**ADDENDUM NO. 1
TO
CONTRACT DOCUMENTS FOR THE CONSTRUCTION OF THE
TURLOCK REGIONAL WATER QUALITY CONTROL FACILITY
CHEMICAL SYSTEM UPGRADES PROJECT AT RWQCF
CITY PROJECT NO. 20-032**

April 22, 2021

ADDENDUM NO. 1

Project No. 20-032

DRAWING NO. SHSE12

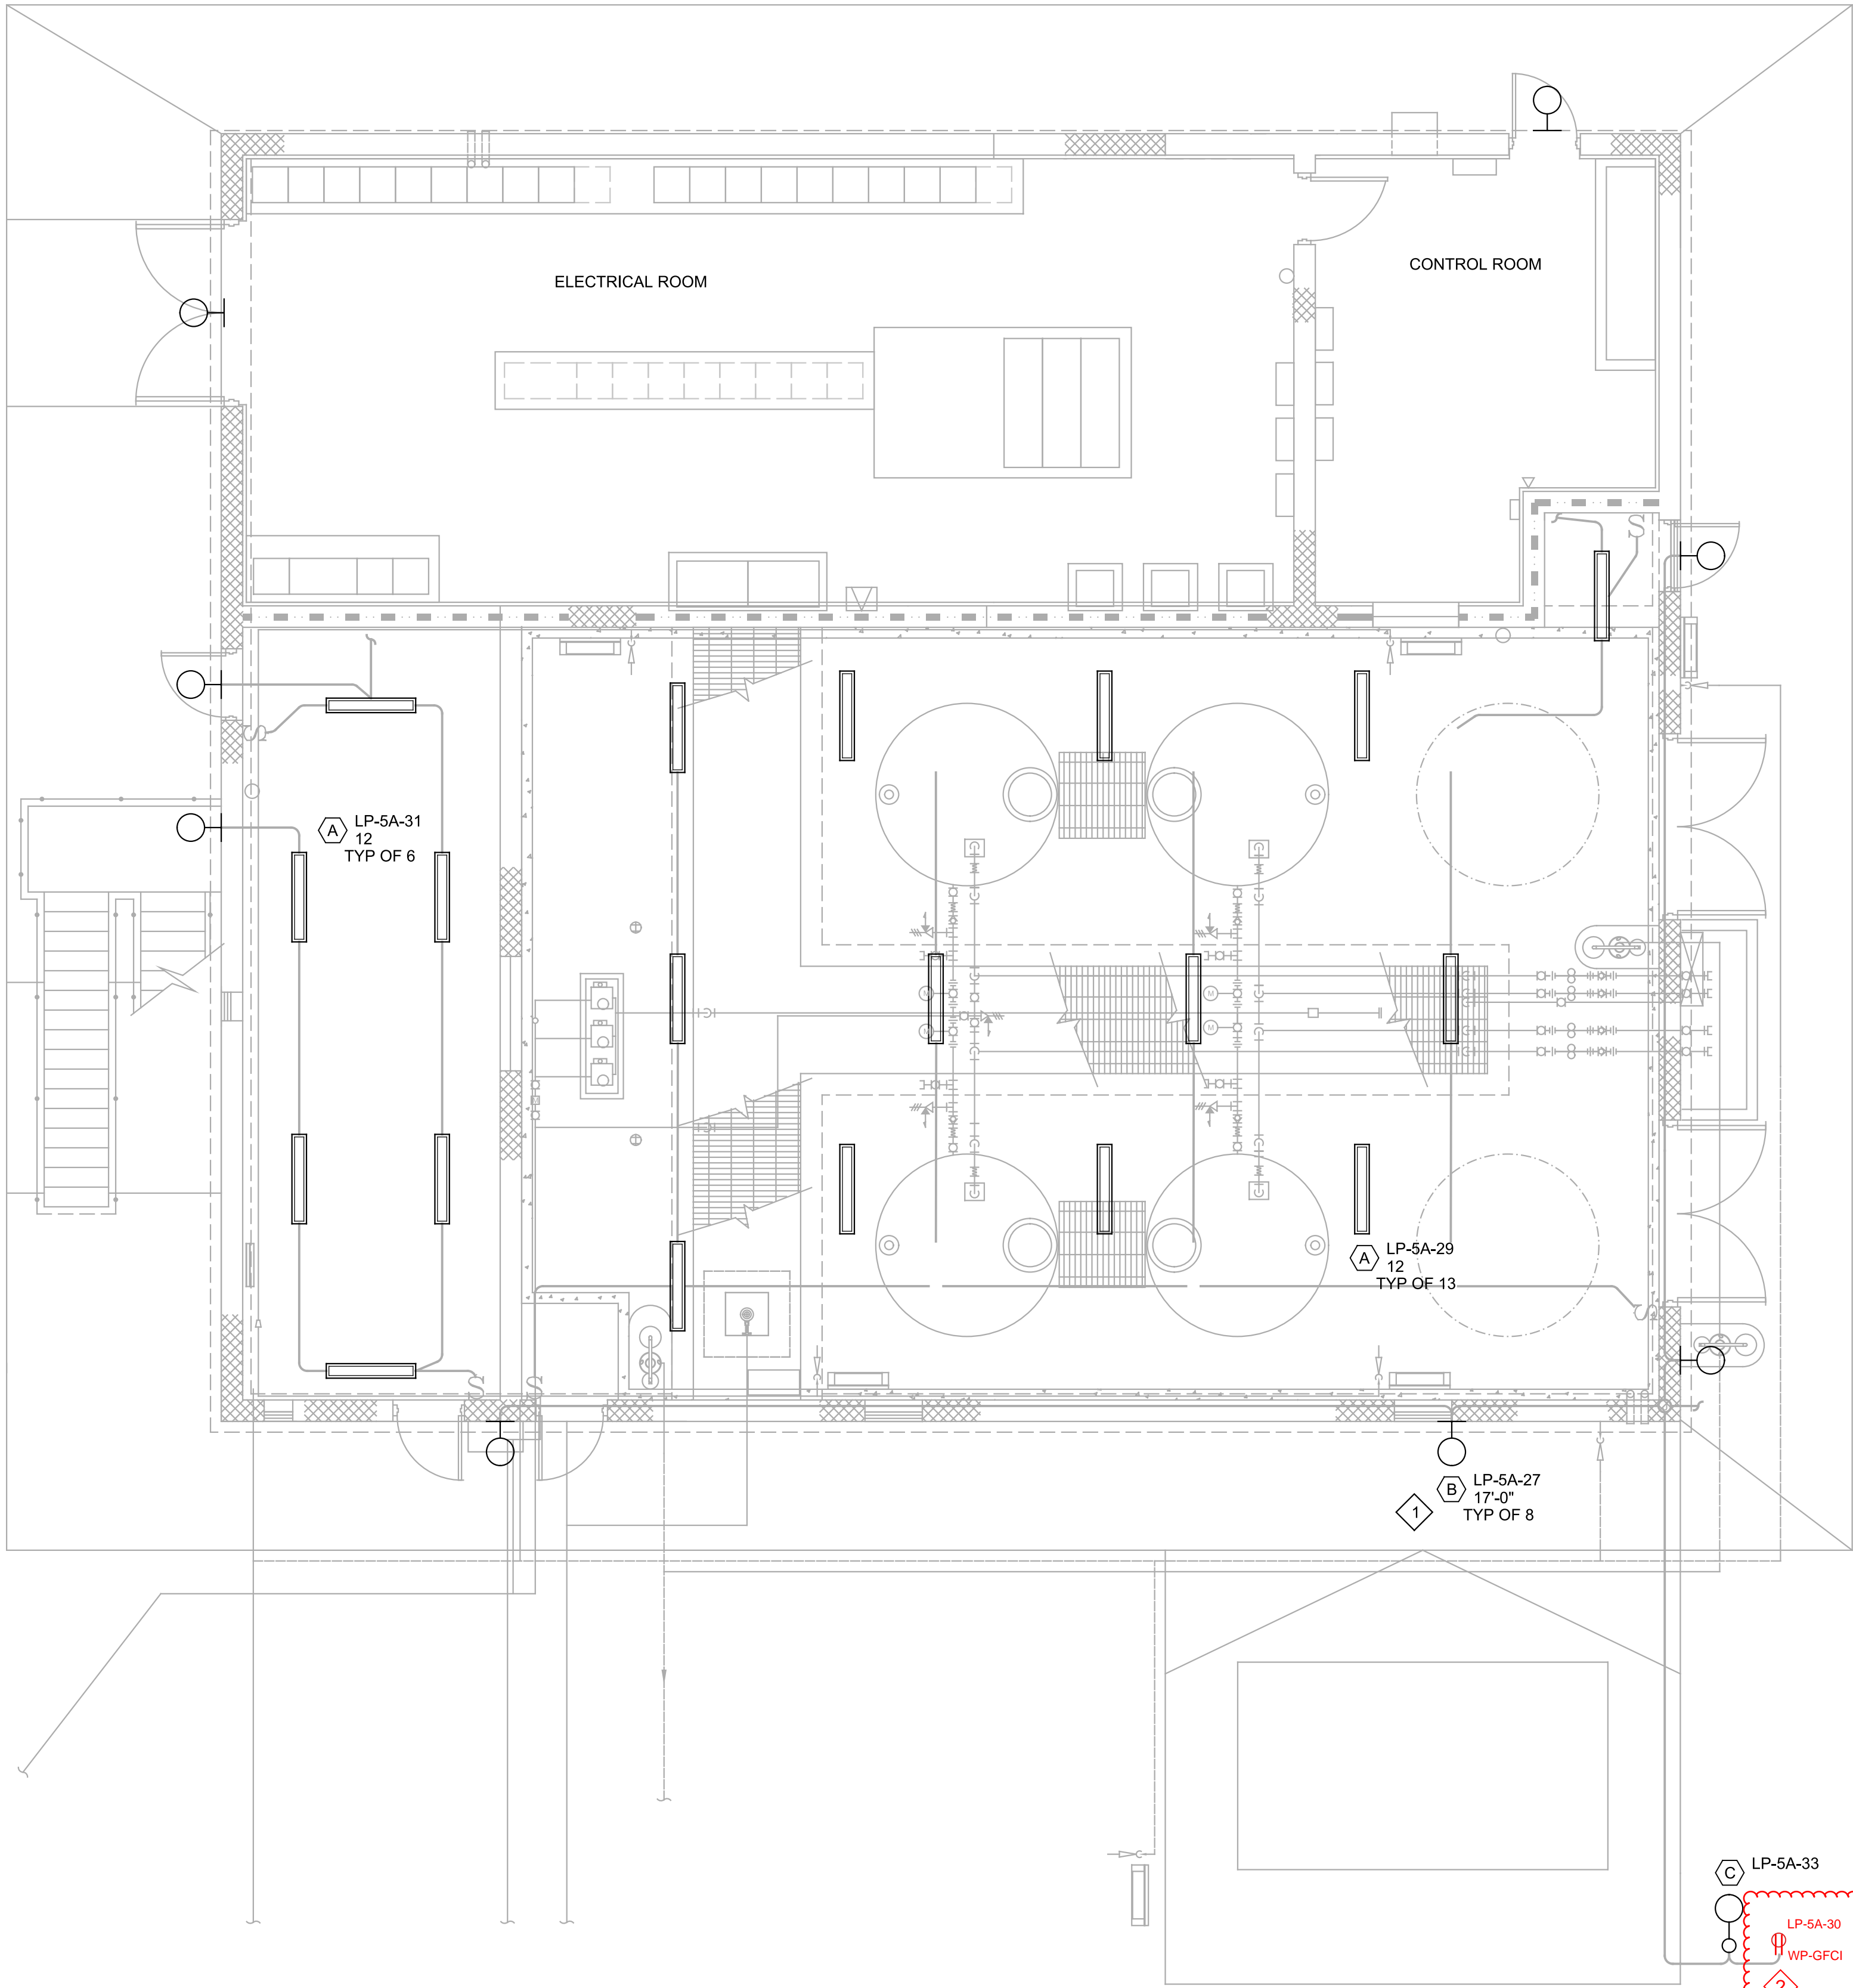
5. Sheet Number 63 of 97, Drawing No. SHSE09
 - A. Replace the drawing with the attached drawing.
6. Sheet Number 66 of 97, Drawing No. SHSE12
 - A. Replace the drawing with the attached drawing.
